**Permit Evaluation
and
Statement of Basis
for
MAJOR FACILITY REVIEW PERMIT
Reopening – Revision 3**

**for
Valero Refining Co. - California
Facility #B2626**

July 2005
Revised September 2006 for Proposed Permit
Revised for Final Permit, March 2007

S-20 Process Furnace, Naphtha Hydrofining, F-104, 62MM Btu/hr

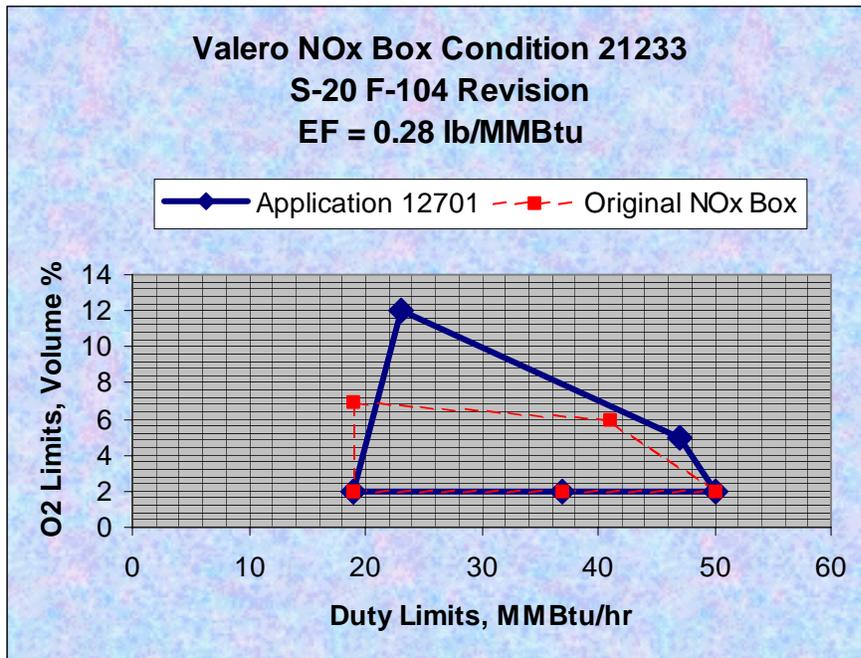
This application requests a change in the NO_x Box operating window for:

The change is as follows:

Source No.	Emission Factor (lb/MMBtu)	Min O ₂ at Low Firing (O ₂ % , MMBtu/hr)	Max O ₂ at Low Firing (O ₂ % , MMBtu/hr)	Min O ₂ at High Firing (O ₂ % , MMBtu/hr)	Mid O ₂ at Mid/High Firing (polygon) (O ₂ % , MMBtu/hr)	Max O ₂ at High Firing (O ₂ % , MMBtu/hr)
Plant B2626						
20 old	0.28	2, 19	7, 19	2, 37	2, 50	6, 41
20 new	0.28	2, 19	12, 23	2, 37	2, 50	5, 47
